PLANNING TECHNICAL REVIEW COMMITTEE –AGENDA

1. 10:30 AM – 11:15 AM: Site Review for First Street at Garrison, LLC, Assessor's Map 6, Lots 3-1 & 9, zoned CBD - General, located at First Street. (Proposal is to re-use the existing building and construct one new building, the first building with 24 two bedroom units and 8 one bedroom units also containing 1,520 sq. ft. of commercial space and 17 covered parking spaces with the second building containing 1 two bedroom units and 5 one bedroom units also with 2,412 sq. ft. of commercial space and a total of 55 proposed parking spaces on site. A CUP and LLA application will also appear before the Planning Board). (P18-25)

TECHNICAL REVIEW COMMITTEE MINUTES - P18-37

- o Change name of project **Changed to "Rivers Mark", all sheets**

TAX MAP SKETCH & NEIGHBORHOOD PLAN
1" = 100'±

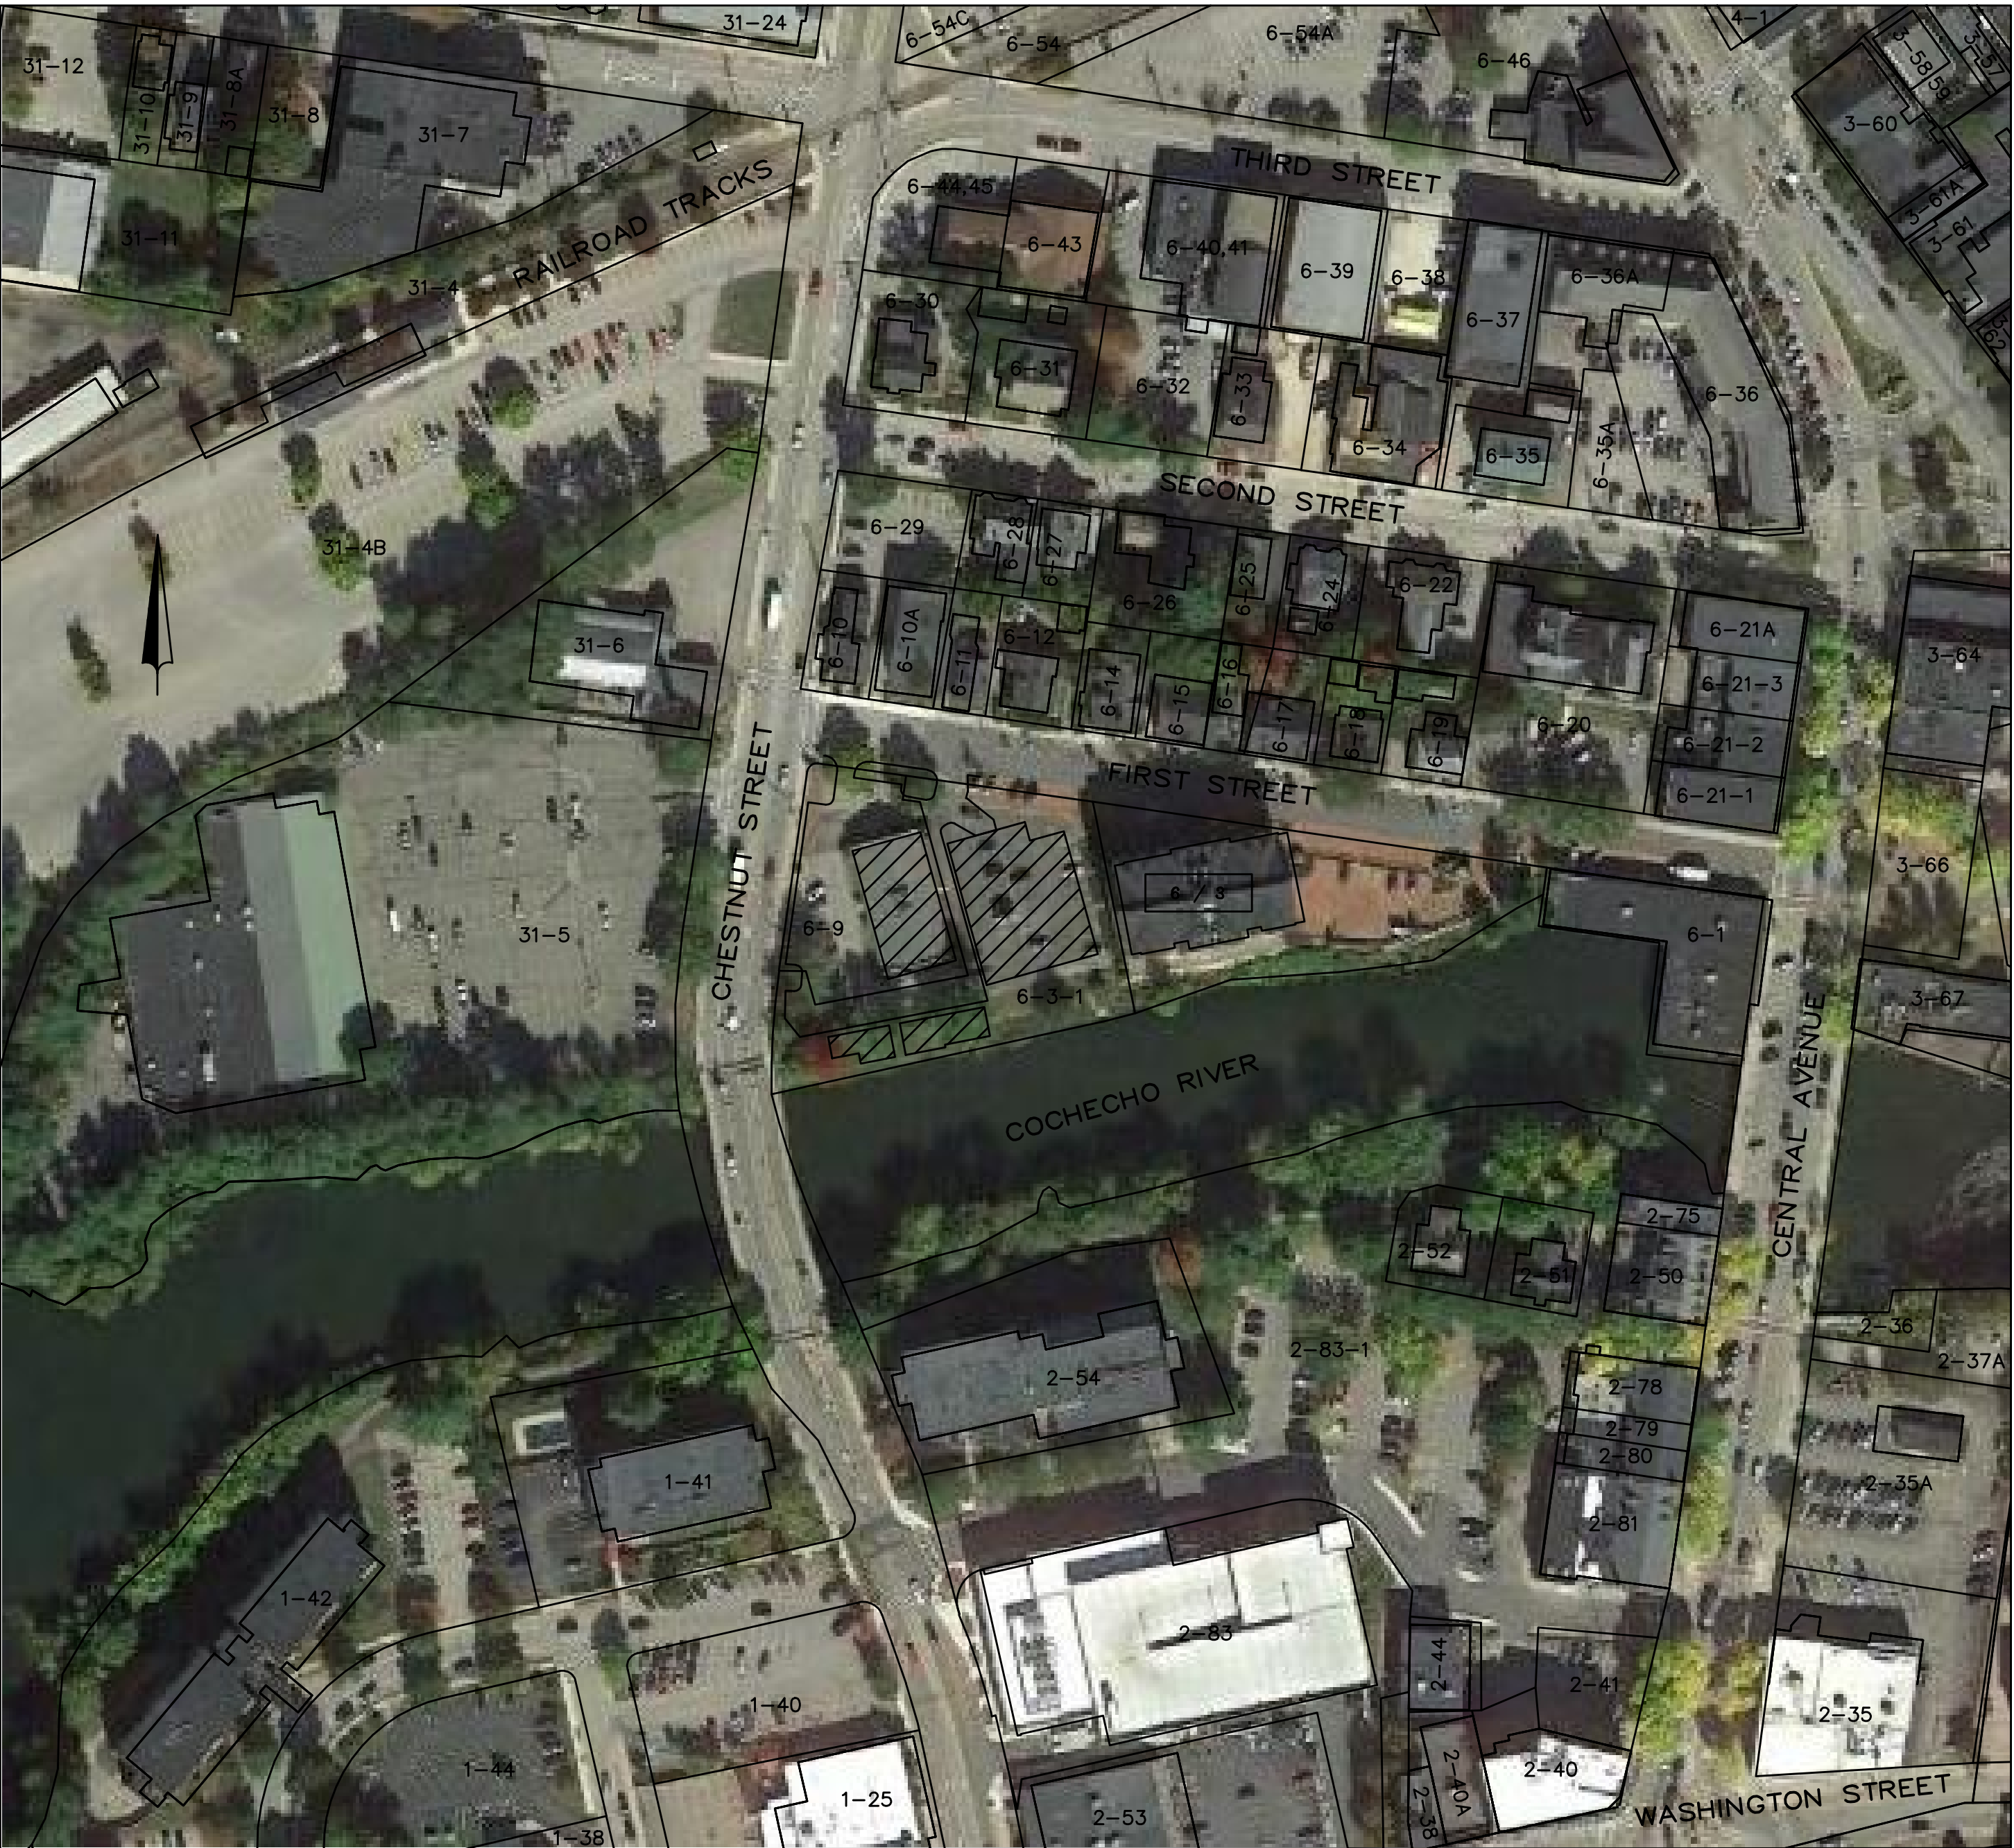
- o Add planning file number P18-25 **Done, all Sheets**
- o Add aerial to neighborhood plan **Done, Sheet 1**
- o Note what is provided to meet zoning requirements of CBD **Done, Sheet 9, note 1**

- Add planning file number 18-25
- Add Aerial photo from Google Earth
- Add revised through August 15, 2018 to title
- Notes Sheet No. 9 added, renumber 9-12 to 10-13
- Sheet 14 added
- Rename project to "Rivers Mark"

SHEET 2

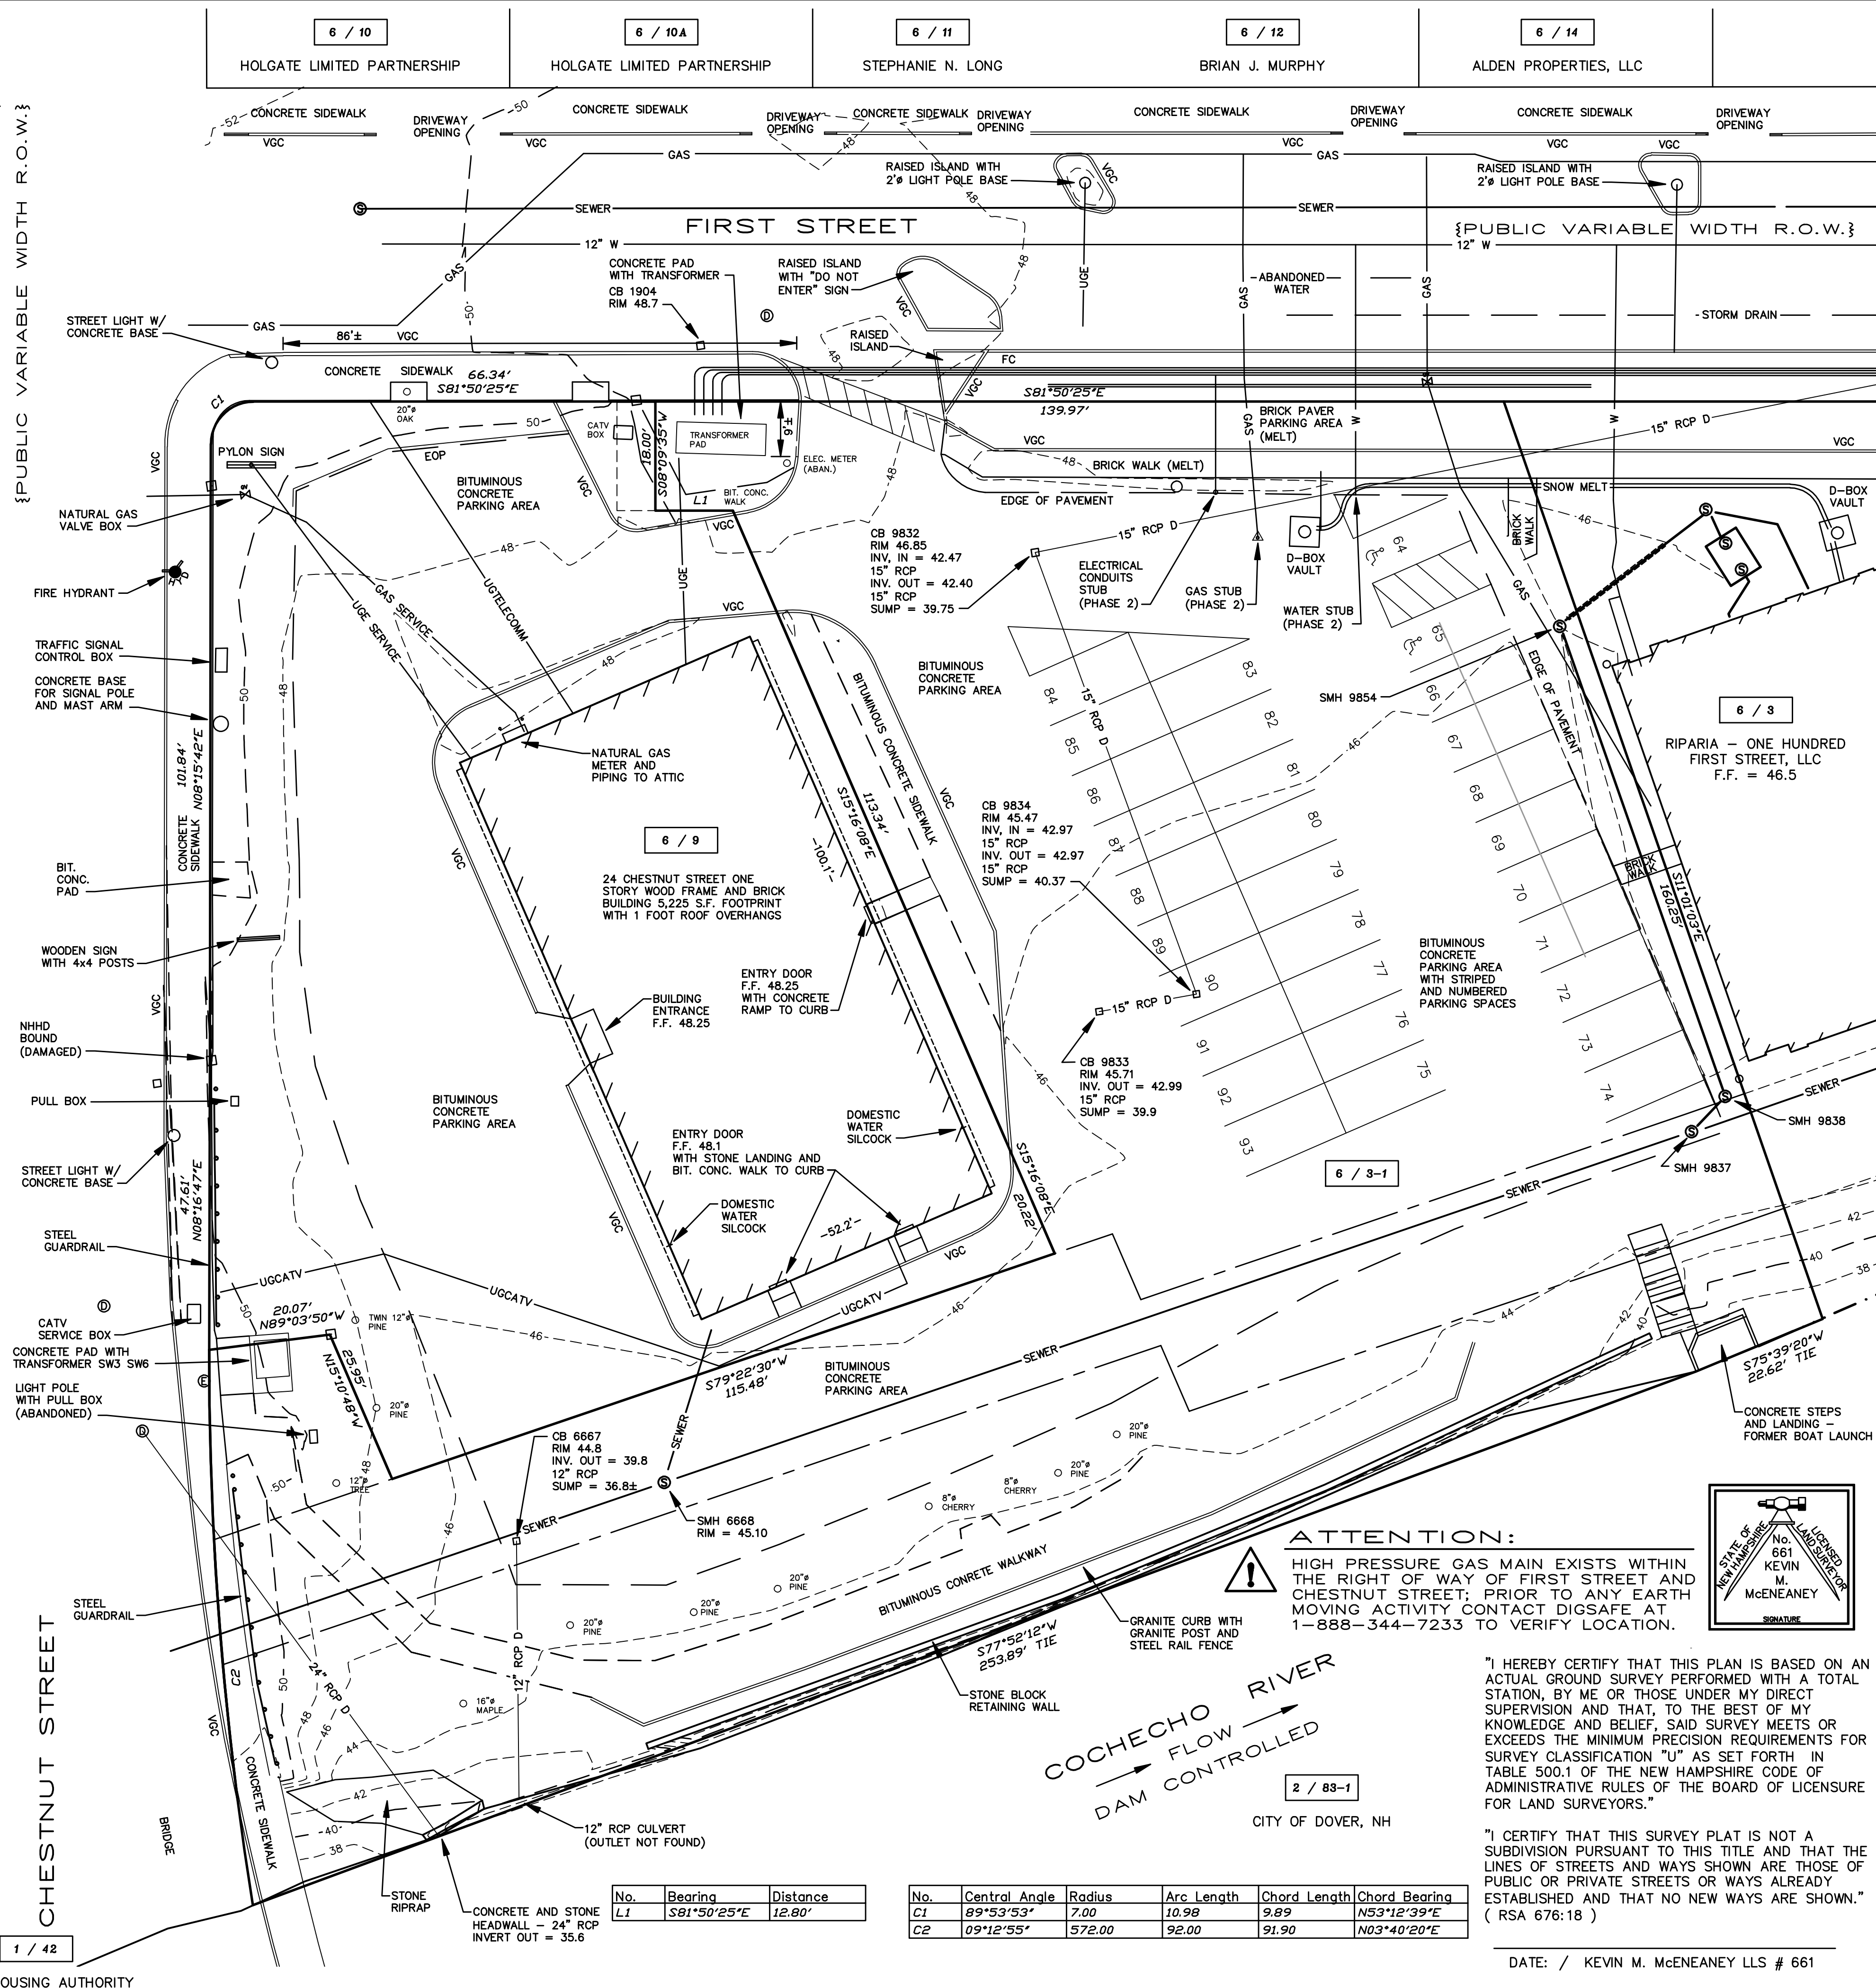
- o Label all street lights **Existing are shown and labeled on Sheet 2**
- o Use proper scale (1" = 20', 30', 40') **Add Sheet 14**
- o Remove drainage under cottage **Done**

- Add planning file number 18-25
- Add Rev 1 – 8/15/18 to block
- Add FF Elev 46.5 to Parcel 6/3
- Rename project to "Rivers Mark"
